Marma Composite LTD

27th May 2014

Observations

**Original building truss
to CHS Connection**

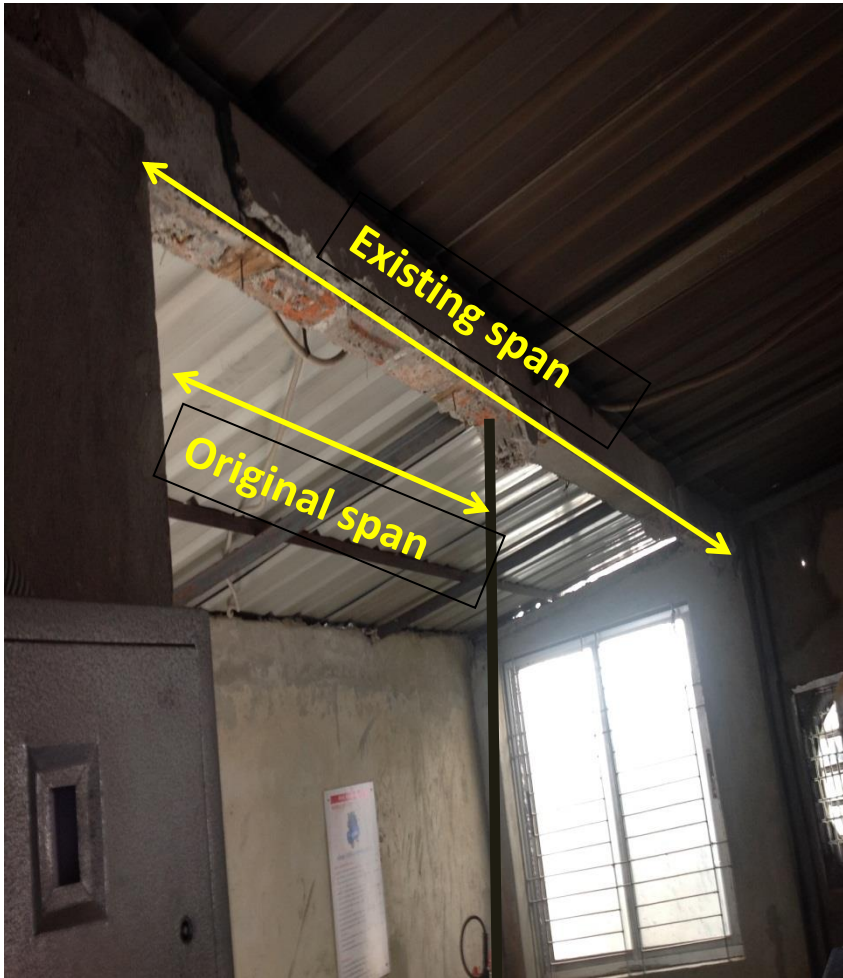
Various steel connections appear non-engineered such as the welded connections for the mezzanine structure in the main factory building, the truss to column connection in the original factory building and the portal frame apex moment connection in the original building extension.

Item No.	Observation	Recommended Action Plan	Recommended Timeline
1	Inadequate bracing systems	Structural engineer to check the capacity of the steel frames under horizontal and vertical loading and make any necessary alterations.	6-months
2	Steel connections appear non-engineered	Structural engineer to check the capacity of all connections and make any necessary alterations.	6-weeks
3	Increased span for the reinforced concrete beam in the generator room	Building manager to temporarily prop the beam.	6-weeks
4	Increased span for the reinforced concrete beam in the generator room	Structural engineer to check the capacity of the beam to ensure it can span the additional length. Structural engineer to recommend any building alterations if required.	6-weeks
5	Lightweight roof structures appear non-engineered	Lightweight roof structure to be reconstructed/upgraded to ensure adequacy for code vertical and wind loads by the Building Engineer.	6-months
